CEPI-63-21 Part II

2021 International Energy Conservation Code

IRCEPI-1-21

REPI-40-21

TABLE R405.4.2(1) SPECIFICATIONS FOR THE STANDARD REFERENCE AND PROPOSED DESIGNS

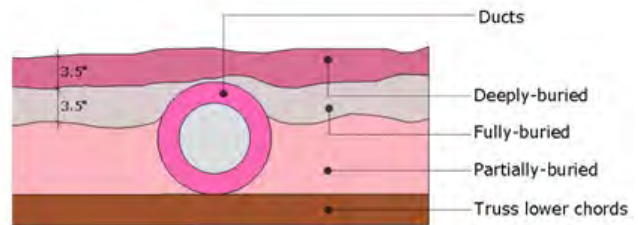
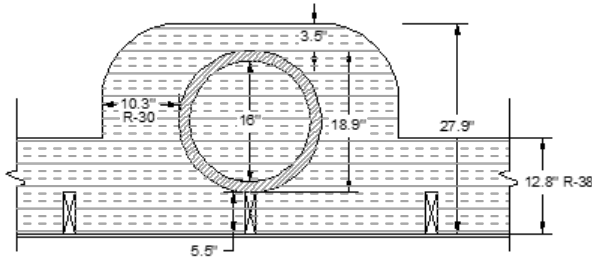
This measure would increase stringency for duct distribution efficiency and encourage ducts in conditioned space and other distribution efficiency alternatives by adding a table that specifies prescriptive requirements for different duct locations and insulation requirements by climate zone. Another table is added that describes effective R-values for partially or fully buried ducts. The exclusion of duct insulation requirements (Section 403.3) is eliminated from the Total Building Performance table. Requirements for fully buried ducts that qualify them as ducts in conditioned space were clarified, as well as for ducts in a non-vented attic that qualify as ducts in conditioned space.

As of 2018 the IECC recognizes buried ducts, but unlike Title 24 (Alternative Calculation Manual 2.4.4.10), IECC apparently provides no performance credit for partially or fully buried ducts, nor does it require a duct design. Deeply buried ducts continue to qualify as DCS and are given an R-value of 25 if they meet specific requirements that are included 2021 IECC Sections R403.3.2(2), R403.3.3(3), and R403.3.3.1. The first figure below (from Shapiro 2013) illustrates differences between partially, fully, and deeply buried ducts. The second figure shows a 16-inch R-8 deeply buried duct installed in an R-38 attic that meets the requirements of R403.3.3.1. Covering the top of the duct with 3.5 inches of blown-in insulation would make the depth of insulation surrounding the duct nearly 28 inches deep. It could be difficult to fit this assembly into a low attic, and insulation to that depth would have to be mounded several feet laterally around the duct to prevent slough-off. In humid climate zones it is necessary to encapsulate the duct in 1.5 inches of spray foam to prevent surface condensation. The 2021 IECC leakage to outside limitation of 1.5 cfm per 100 ft² of conditioned floor area may

- Add prescriptive alternatives for partially/fully buried ducts and for ducts in high performance attics for all climate zones and include a table in R403.3 that provides a single, conservative equivalent duct insulation value for partially or fully covered ducts given the attic insulation R-value and the diameter of the largest duct.
- Change the current requirement for R-13 duct insulation in Zones 0A-3A when ducts are fully buried to a requirement to encapsulate them in 1.5 inches of closed cell spray foam insulation.
- Consolidate all deeply buried duct requirements (qualifying it as DCS) in one code section, including insulation requirements and duct leakage.
- Explicitly add ducts and air handlers in a non-vented attic that is inside the *continuous air barrier* as a DCS option.

BUILDING COMPONENT	STANDARD REFERENCE DESIGN	PROPOSED DESIGN
Thermal distribution systems	<p>Duct insulation: in accordance with Section R403.3.1. A thermal distribution system efficiency (DSE) of 0.88 shall be applied to both the heating and cooling system efficiencies for all systems other than tested duct systems. Duct location: same as proposed design.</p> <p>Exception: For nonducted heating and cooling systems that do not have a fan, the standard reference design thermal distribution system efficiency (DSE) shall be 1. For tested duct systems, the leakage rate shall be 4 cfm (113.3 L/min) per 100 ft² (9.29 m²) of conditioned floor area at a pressure of differential of 0.1 inch w.g. (25 Pa).</p>	<p>Duct location: as proposed. <u>For ducts complying with Section R403.3.3, ducts shall be considered in conditioned space.</u></p> <p>Duct insulation: as proposed. <u>For ducts complying with Section R403.3.2, the effective R-value of the duct shall be considered as listed in Table R403.3.2. For ducts complying with Section R403.3.3 the effective R-value shall be R-25.</u></p> <p>As tested or, where not tested, as specified in Table R405.4.2(2).</p>
